2006 - 2009 Cadillac XLR XLR-V: Service Bulletin: Slips in Reverse or Third, Delayed Reverse or Drive Engagement

#09-07-30-004J: Slips in Reverse or Third, Delayed Reverse or Drive Engagement, DTC P0776, P2715, P2723, Harsh 2-3 Shifts (Inspect 1-2-3-4 / 3-5-R Housing and Pump Seal Rings) - (Feb 25, 2014)

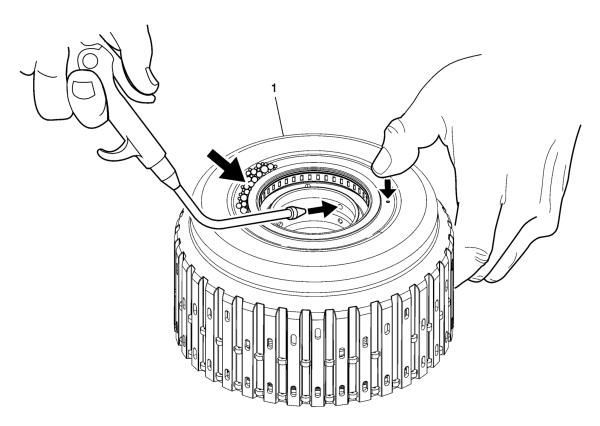
This condition may be caused by a cracked 1-2-3-4 / 3-5-R clutch housing.

Important: If a cracked housing is identified, it must be replaced. Complete, assembled 1-2-3-4 / 3-5-R clutch housings are now available for most applications. These clutch housings come complete with all pistons, seals, clutches, bearing and internal parts. No assembly of the clutch housing is required before it is installed. For applications without a complete, assembled 1-2-3-4 / 3-5-R clutch housing, individual parts must be ordered and the housing assembled in the

Housing Disassembled

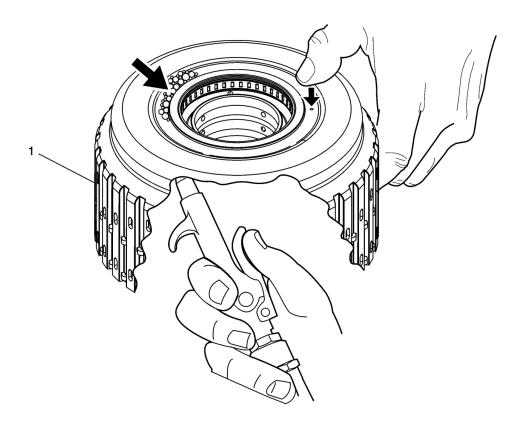
Inspect the 1-2-3-4 / 3-5-R clutch housing for a possible cracked weld.

- 1. Apply soap compound to weld area of the housing.
- 2. Hold your thumb over the air bleed passage.
- 3. Spray compressed air into the housing and inspect the weld area for bubbles.
- 4. If bubbles are detected, a new housing is required.

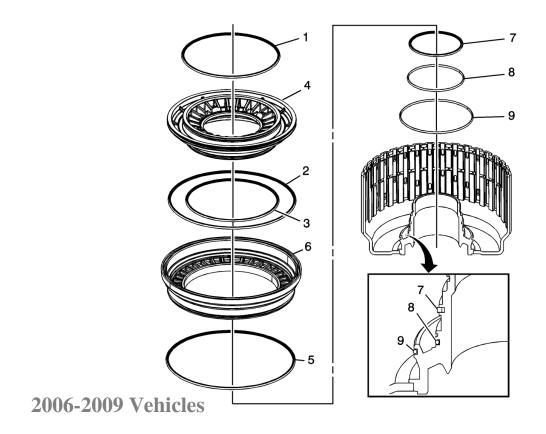
Important: The 6L80 transmission had a design change to the 1-2-3-4 piston, 1-2-3-4 piston housing and the 3-5-R piston for the 2008 model year. Installation of a 2008, 6L80 complete housing assembly into a 2007 or older 6L80 may result in a 2-3 shift flare or 3-5-R clutch distress.

Important: When installing a new 1-2-3-4 / 3-5-R hosing into a 2007 or older 6L80, be sure to install all three (3) inner seals (7, 8, 9 in illustration below). Failure to install these seals can result in no reverse, no forward or distressed clutches.

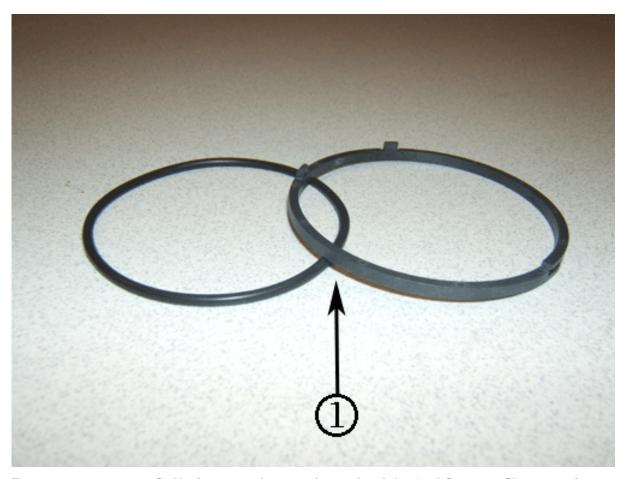
A harsh 2-3 shift condition may be caused by leaking 1-2-3-4 and 3-5-R clutch fluid seal rings (1) on the transmission fluid pump cover assembly.

Inspect the fluid seal rings. Transmissions in 2006, 2007, 2008 and early build 2009 models used a 1- piece design seal ring in production. Starting December 2008, a 2-piece seal ring design was implemented. The 1-piece seal ring design may cause a harsh 2-3 shift due to leakage. This is typically a low mileage issue. If the seal rings are a 1-piece design they should be replaced with new 1-piece design seal rings. It is not necessary to replace the pump cover.

Notice: The clutch fluid seal rings must be installed in a specific way. Failure to install new clutch fluid seal rings in the proper orientation may cause a repeat harsh 2-3 shift. Refer to 1-2-3-4 and 3-5 Reverse Clutch Fluid Seal Ring Installation (6L80/90) in SI for correct installation.
